**MP10\_0186 – Airds Bradbury Urban Renewal Concept Plan, Campbelltown**

### Airds Bradbury Urban Renewal Concept Plan, Campbelltown

**PROPOSED AIRDS BRADBURY RENEWAL PROJECT (1007/2011/DA-MP)**

**Re: Airds Bradbury Renewal Project (1007/2011/DA-MP)**

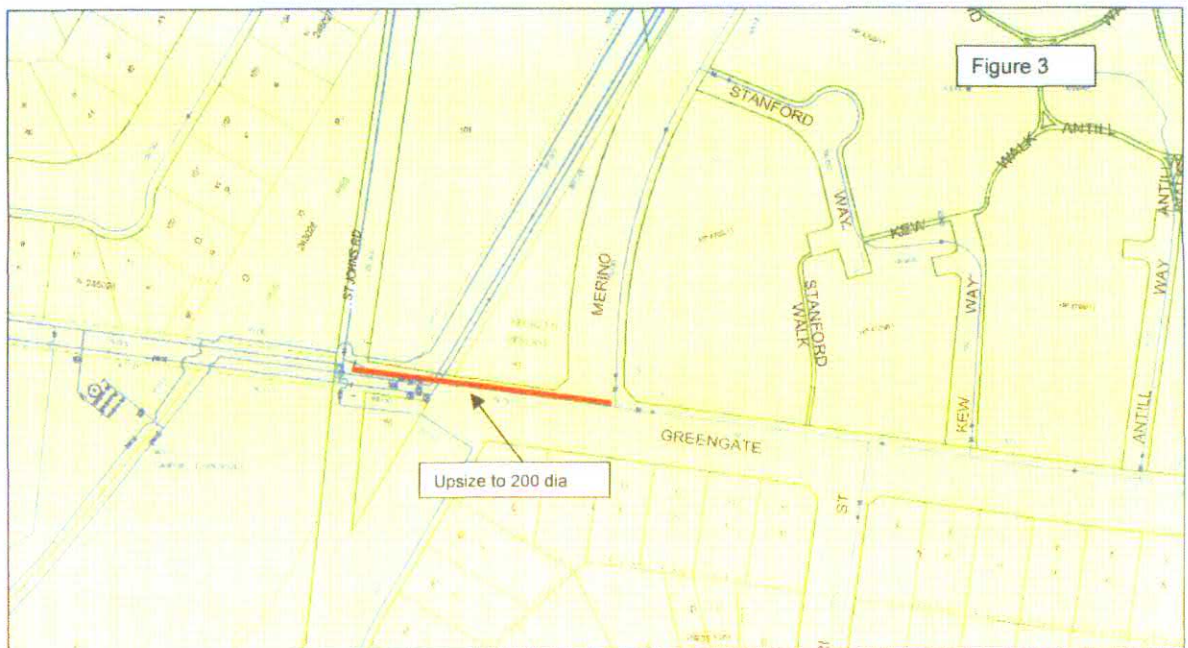
The proposed redevelopment of the existing Airds and Bradbury housing estates is to be serviced via a 200mm drinking water main which is to be laid in Greengate Road as shown on the figure below. Preliminary investigation indicates that the 150mm main can either be upsized to a 200mm main or a new 200mm main can be laid parallel, depending on detailed design. Sydney Water will review this when the developer applies for a Section 73 Certificate.

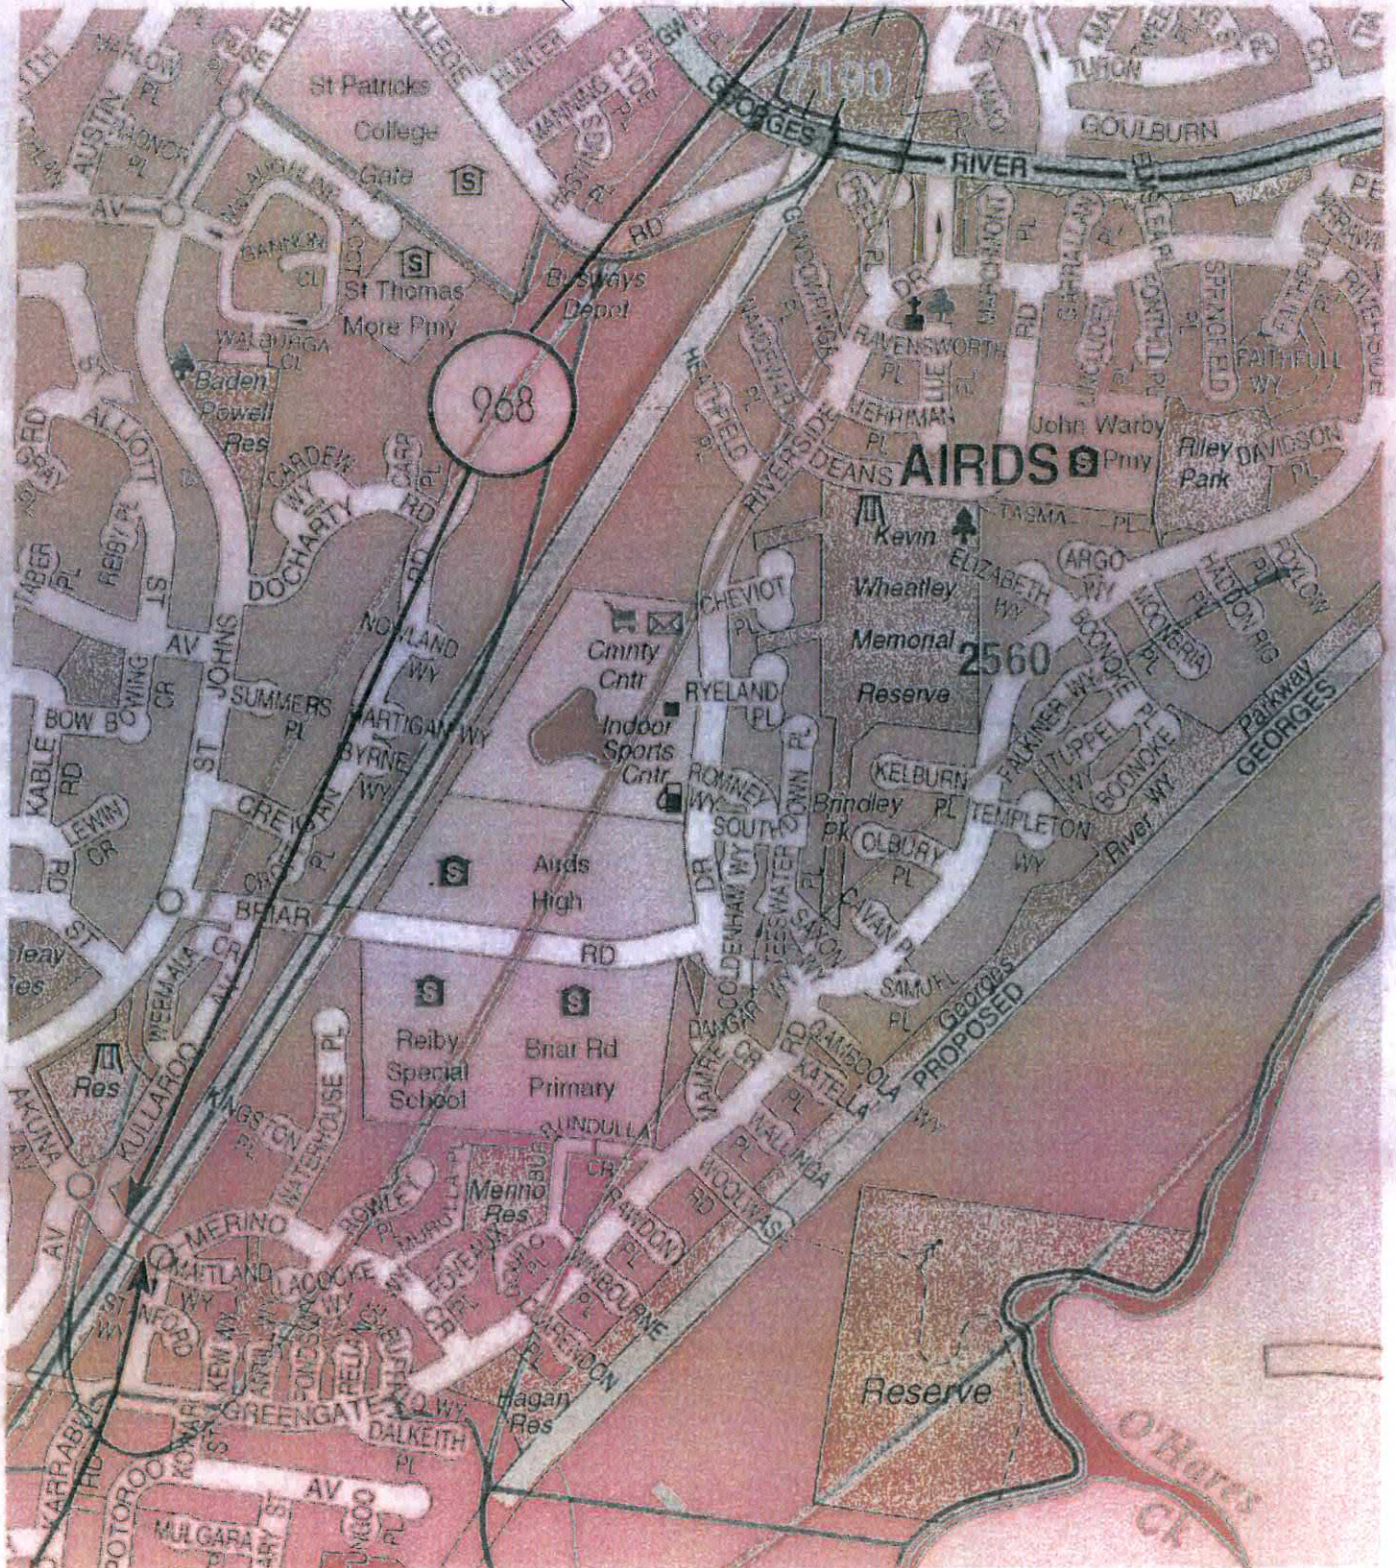
1. The proposal should be referred to the Department of Planning & Infrastructure (DP&I) given the proximity of the two transport corridors in this location, as shown by green colour on the attached plan, that they have a vested interest upon.
